CPC - ALTON RD
1801 ALTON RD.
MIAMI BEACH, FL 33139

ADDENDUM C - PLAN REVIEW RESPONSES

JPM Chase - Alton Road
CPC Interior Renovations
1801 Alton Road
Miami Beach, Florida

ELEVATION AT FRONT OF TELLER LINE SCALE 1/4"=1'-0" 1

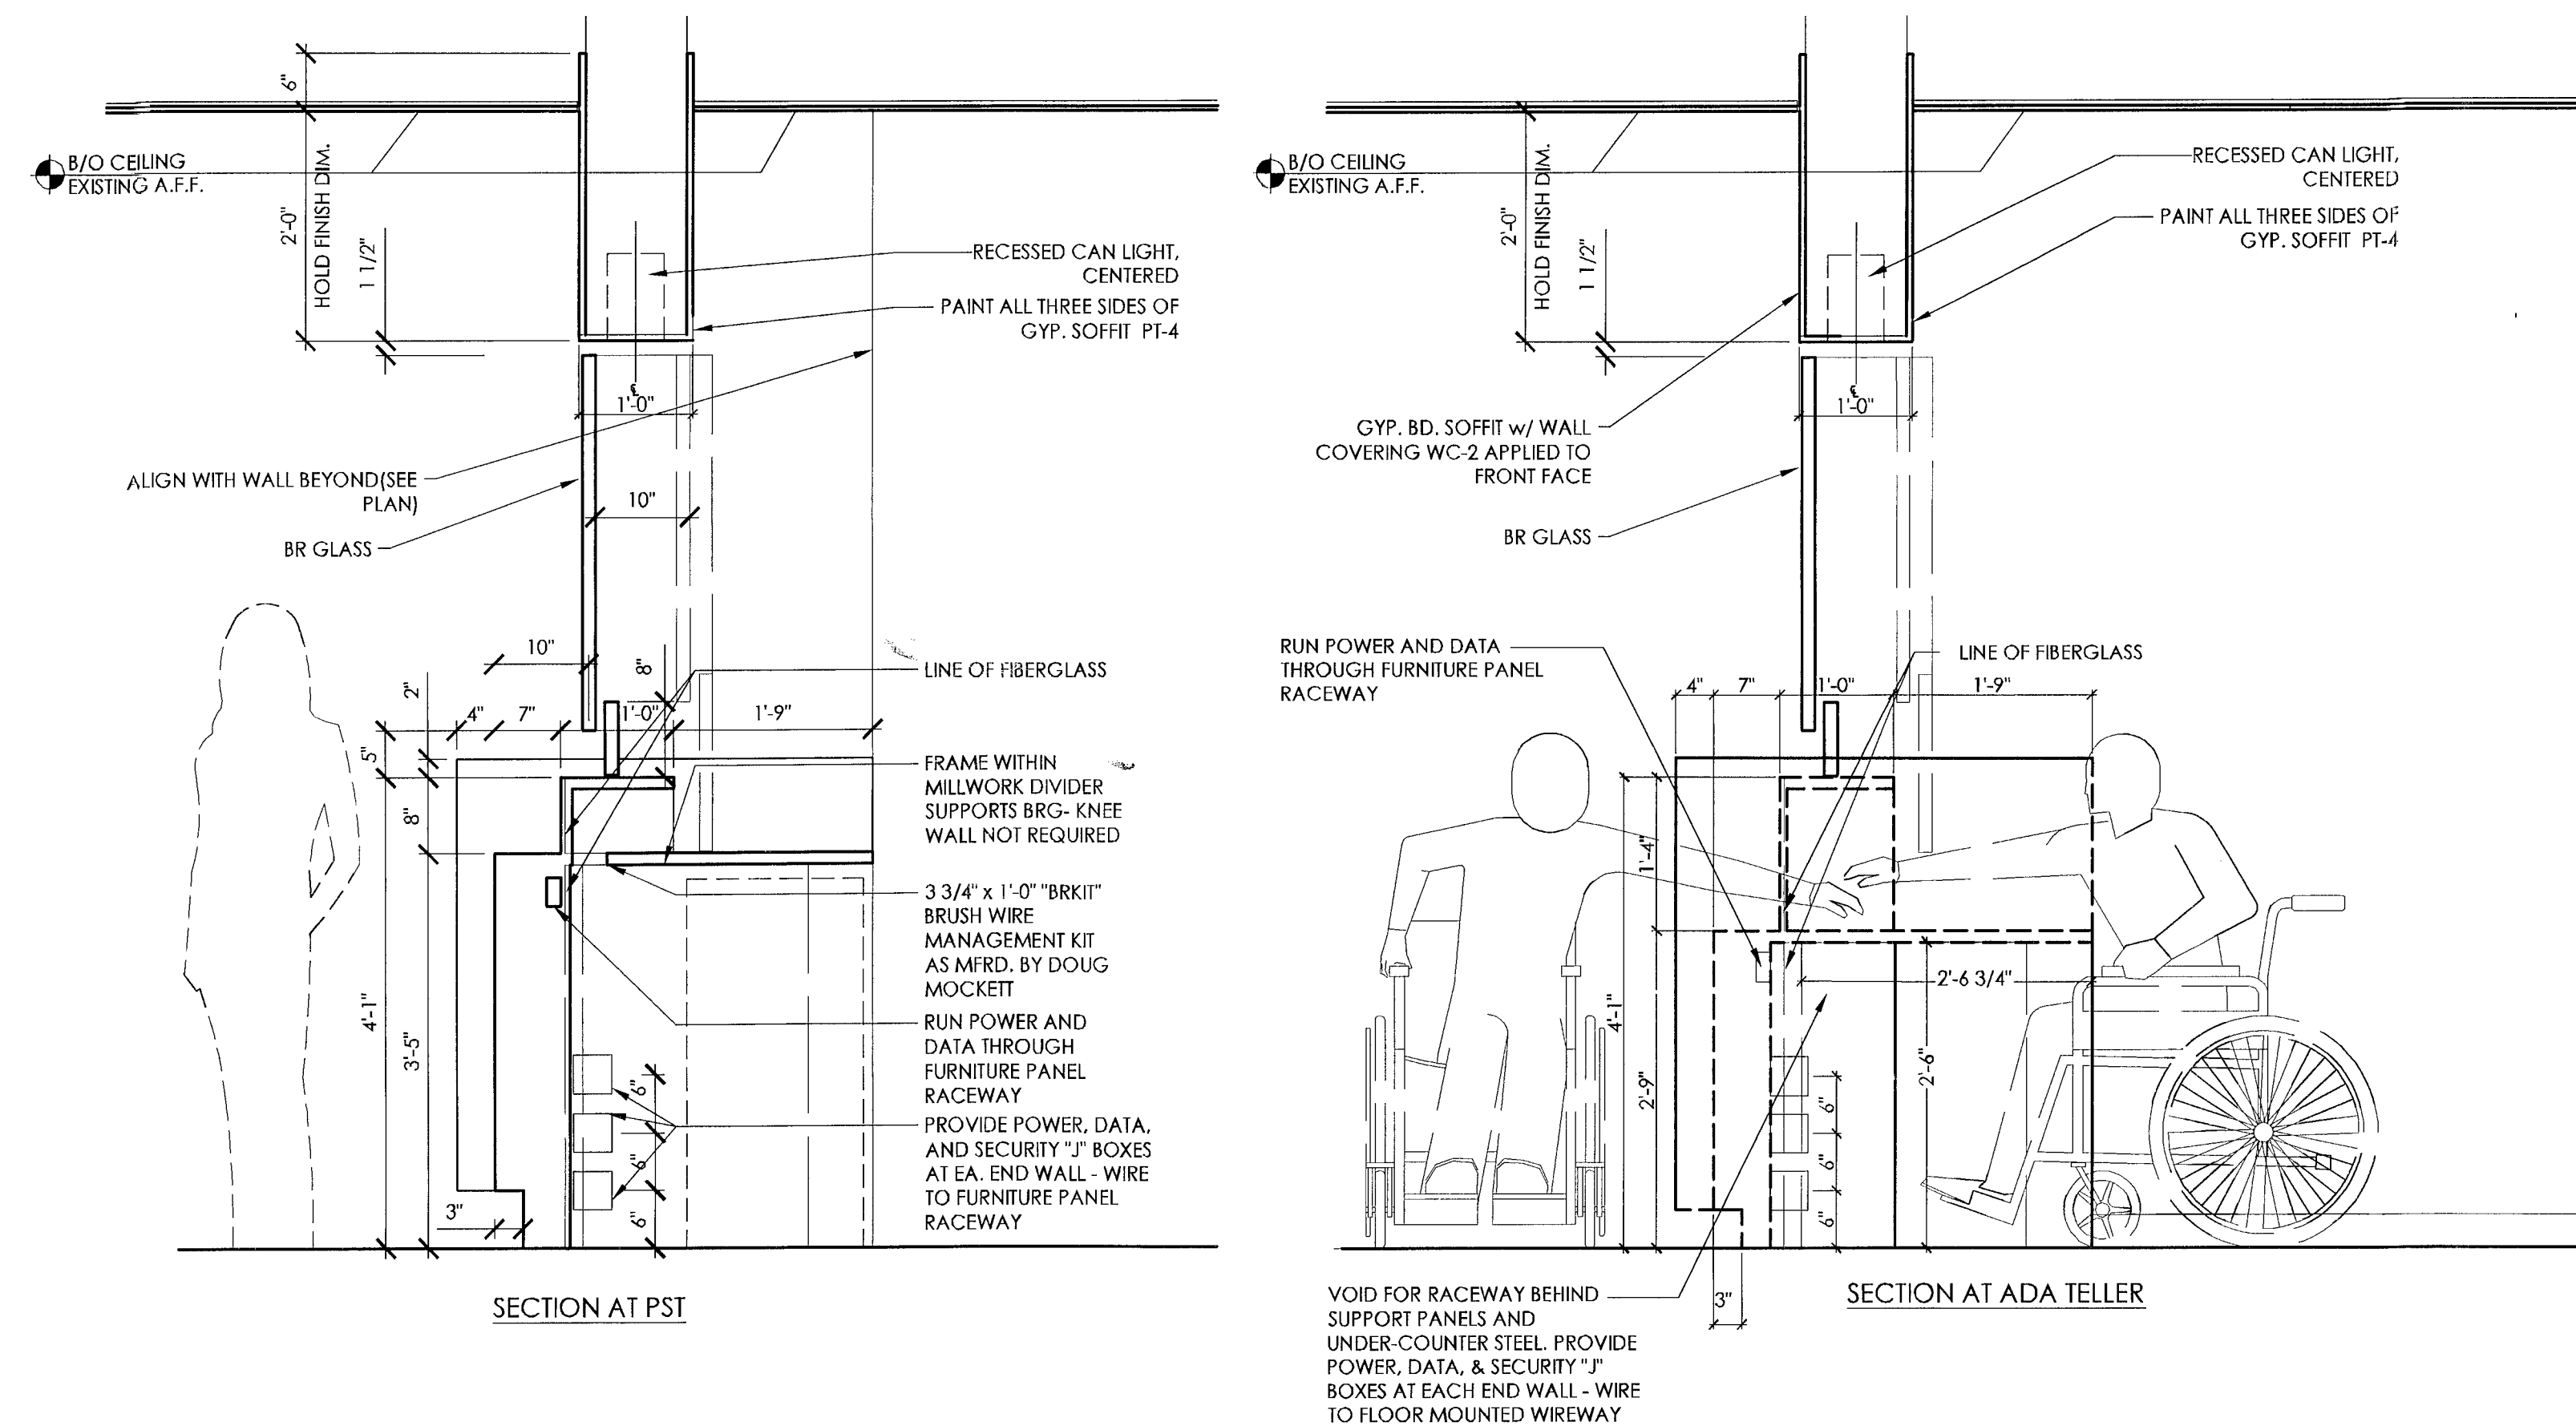
8. **Elevation 1/A5.1: Provide accessibility sign to comply with FAC §216.**
RESPONSE: Please refer to attached revised sheet A5.1, detail 1, for requested detail.

9. **Elevation 1/A5.1: Provide length of accessible teller counter, 36" minimum, to comply with FAC §904.4.**
RESPONSE: Please refer to attached revised sheet A1.2, detail 2 for requested information.

EXISTING CHECK DESK SCALE 3/8"=1'-0" 9

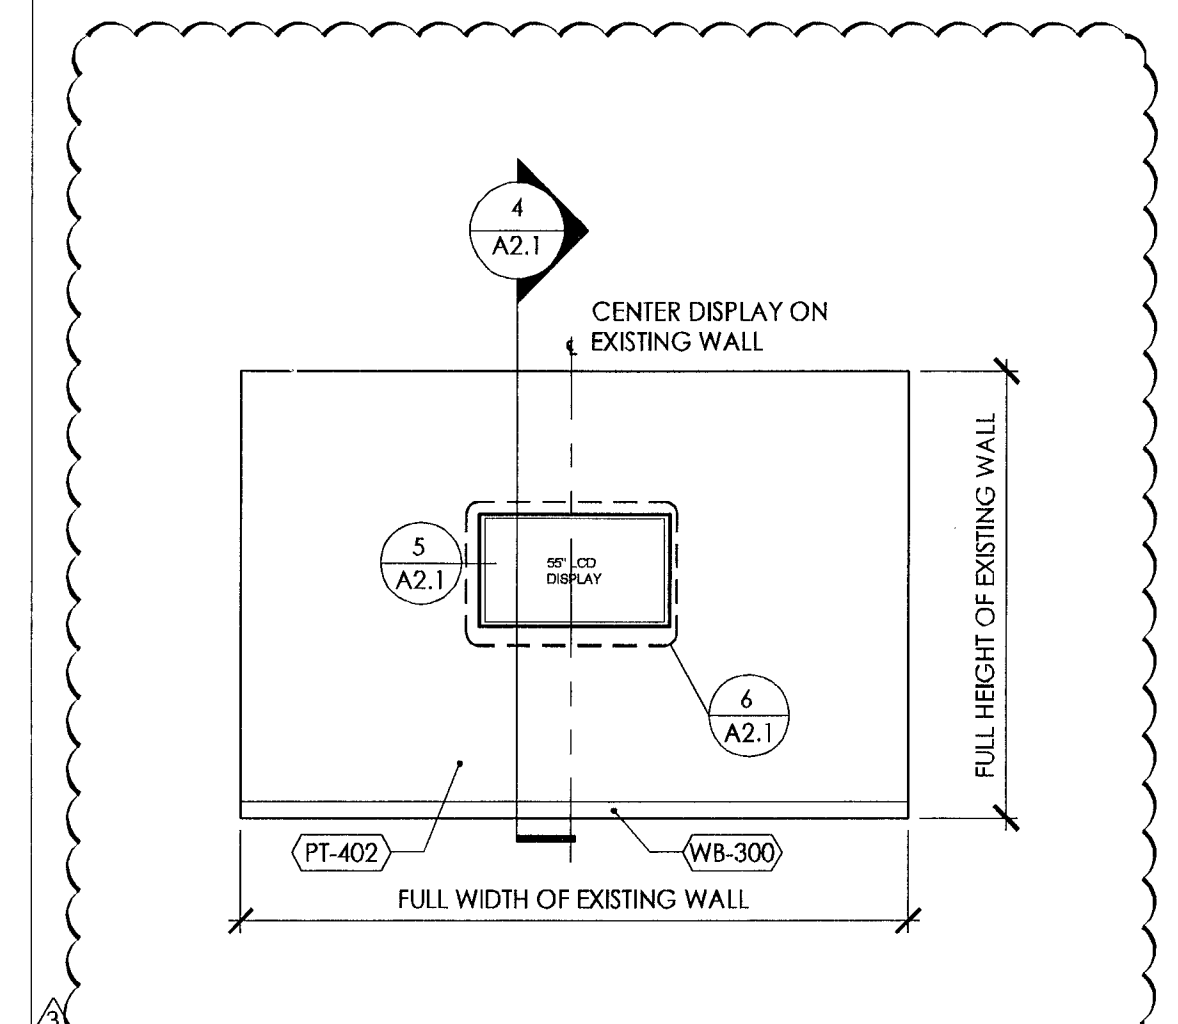
7. **Plan 2/A1.2: Check desk FP09: Provide check writing desk accessible details to comply with FAC §904.3.3.**
RESPONSE: Please refer to attached revised sheet A5.1, detail 9, for accessibility assessment of existing check desk to be relocated.
